Canyon Creek PD Amendment No.11

ZON2025-00001

Canyon Creek Planned Development Amendment No. 11

ZON2025-00001 Canyon Creek PD Amend. No.11 (F5) 1st Review

DEVELOPMENT PLAN
SHEET 2 OF 8

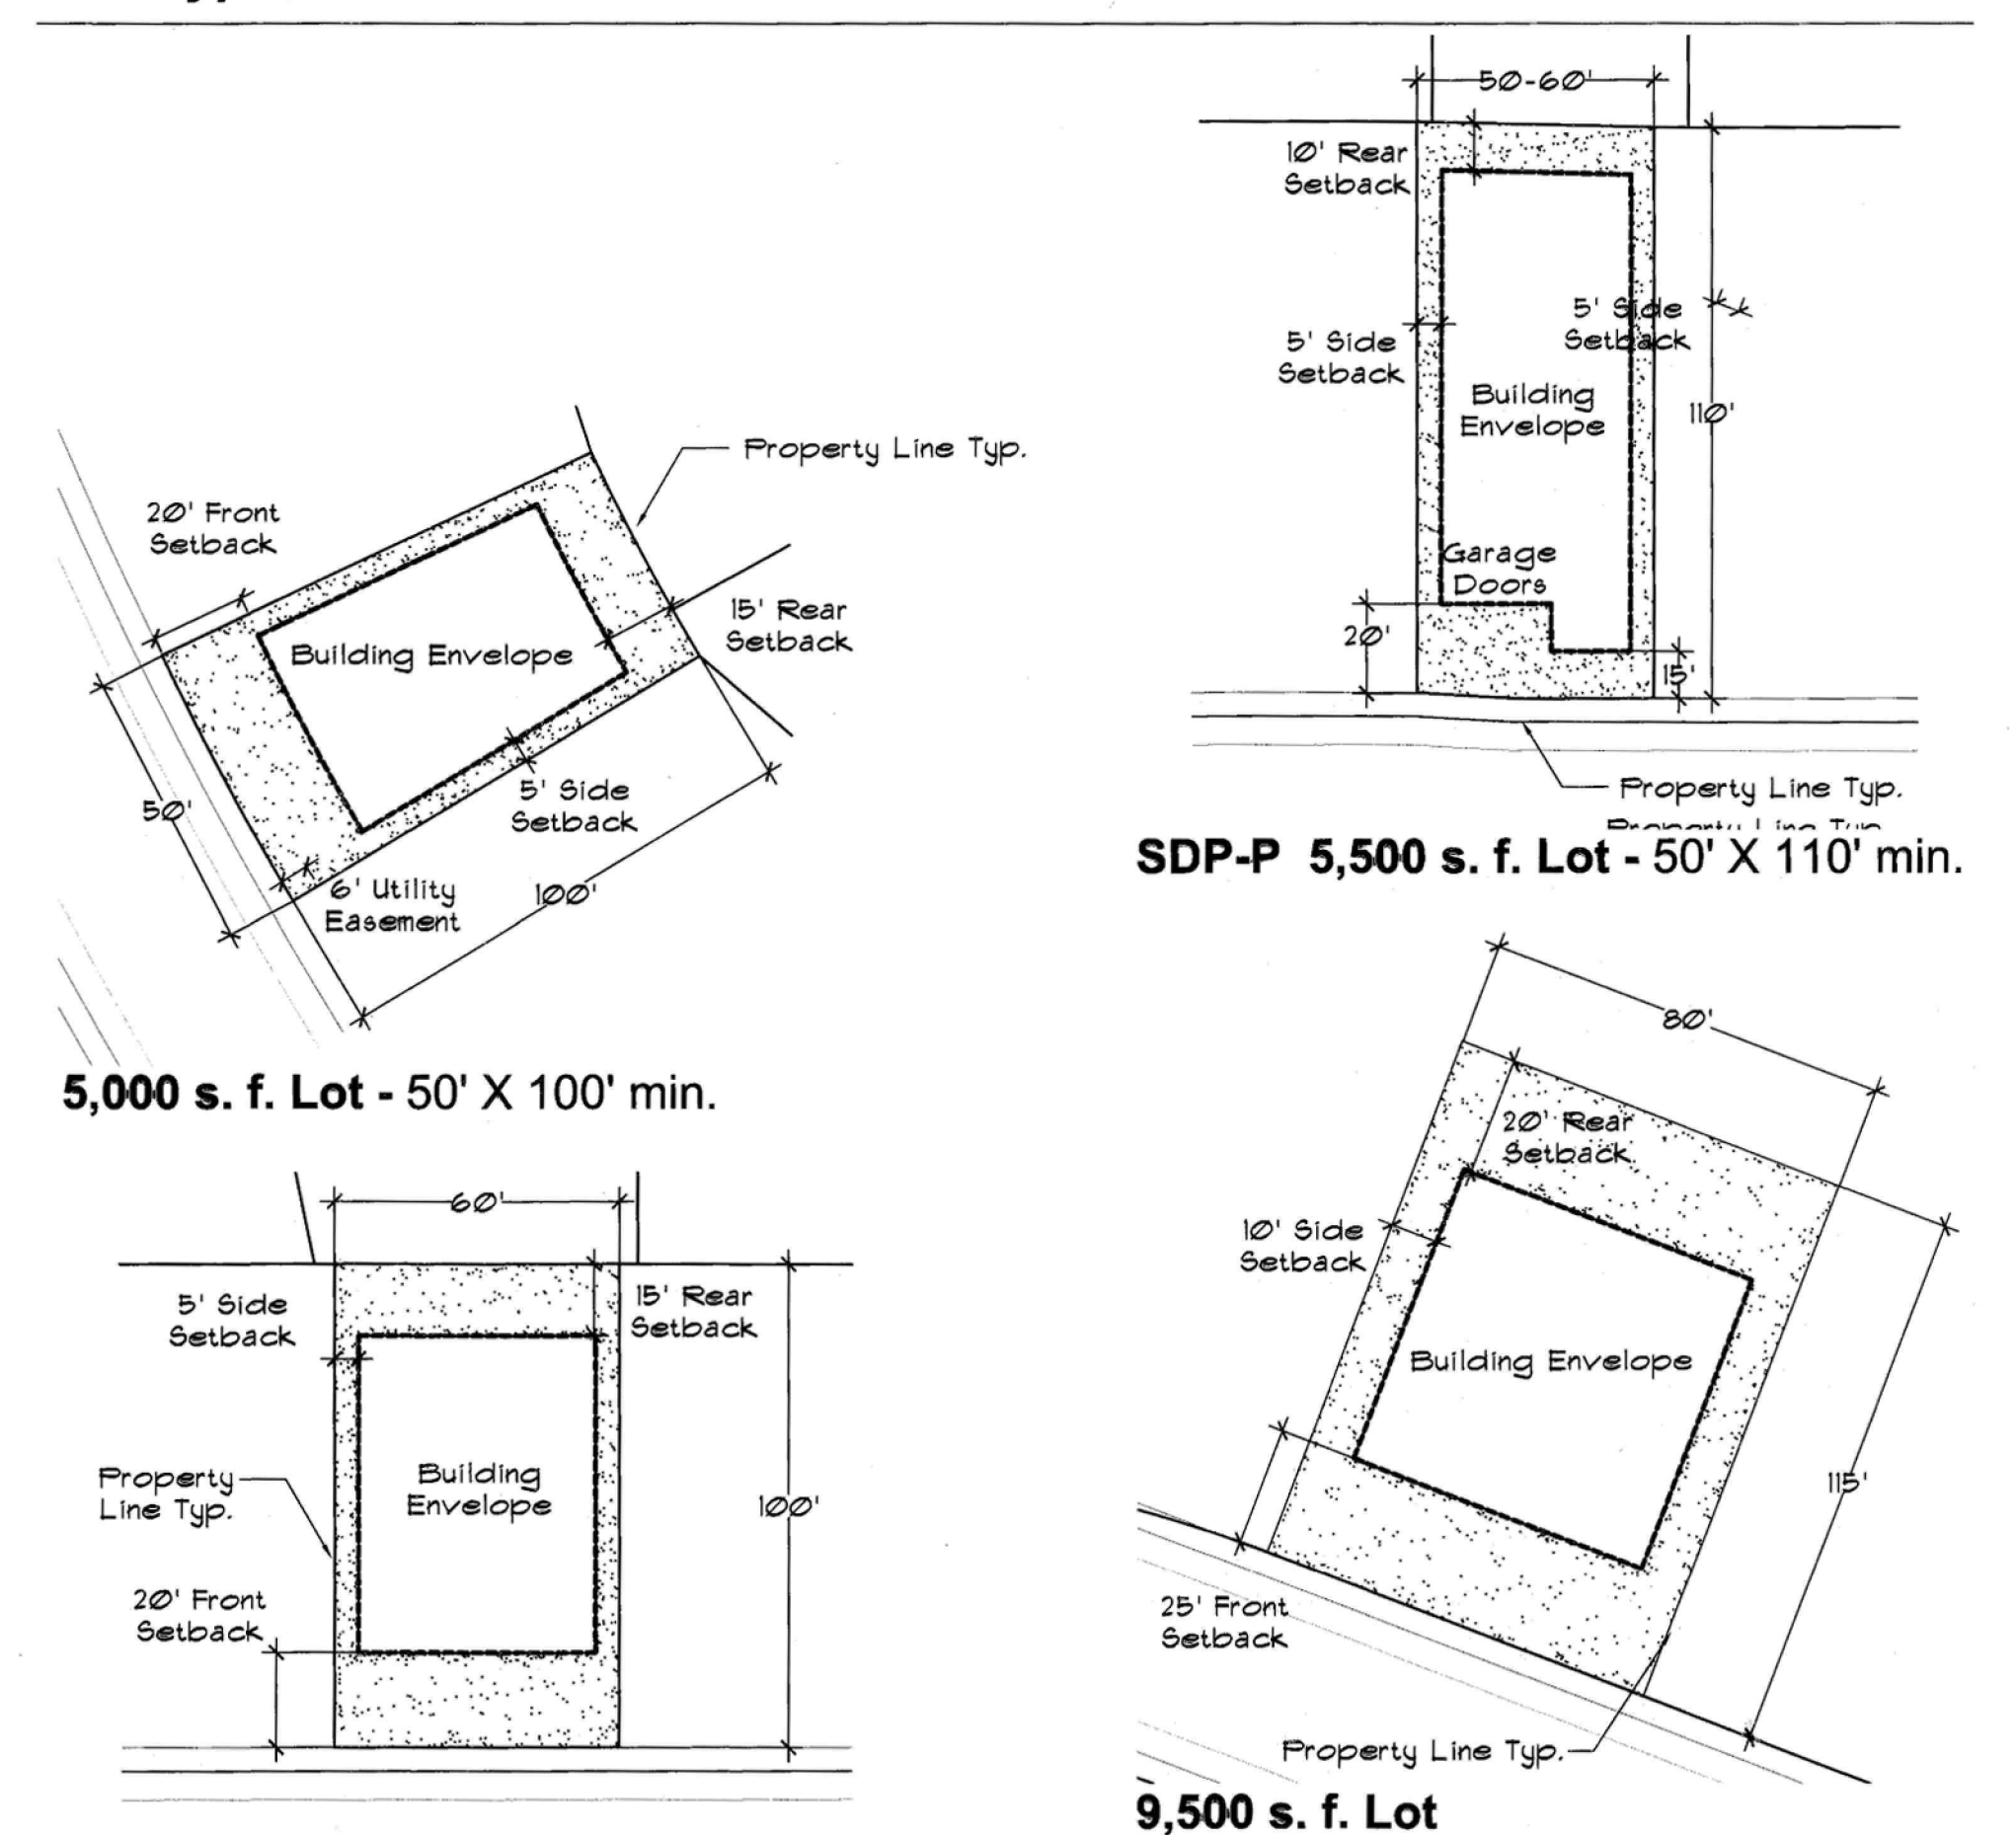
Food and Beverage in Filing 5

Filing 10 is no longer in this PD, so if we could remove it from the table that would be helpful cleanup

Filing 10 is no longer in this PD, so if we could remove it from the table that would be helpful cleanup
